**Sonex Aircraft, LLC**

**Alternator Mount Plate  
Modification Drawing**

ACV-A01-13

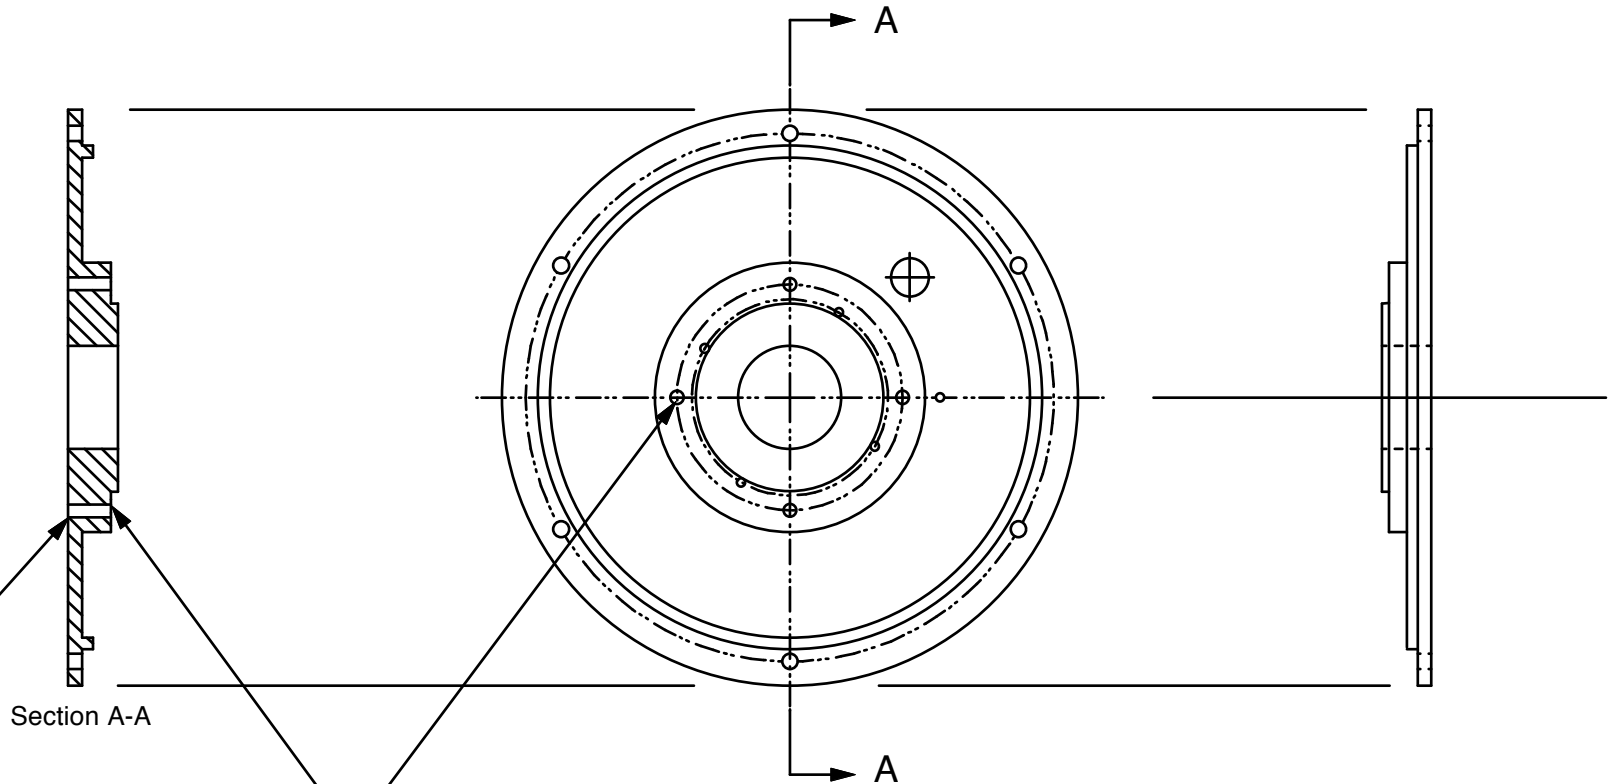
Changed 8-32 Tap Holes  
(Qty 4) to be Thru Holes

Note: Once installed,  
Alternator Mount Screws  
MUST NOT Protrude out  
the back side of the plate.

Drill #29 Thru.  
TAP 8-32 THRU  
TYP. 4 PLACES  
From this Side  
(Fwd side as installed on  
Engine)
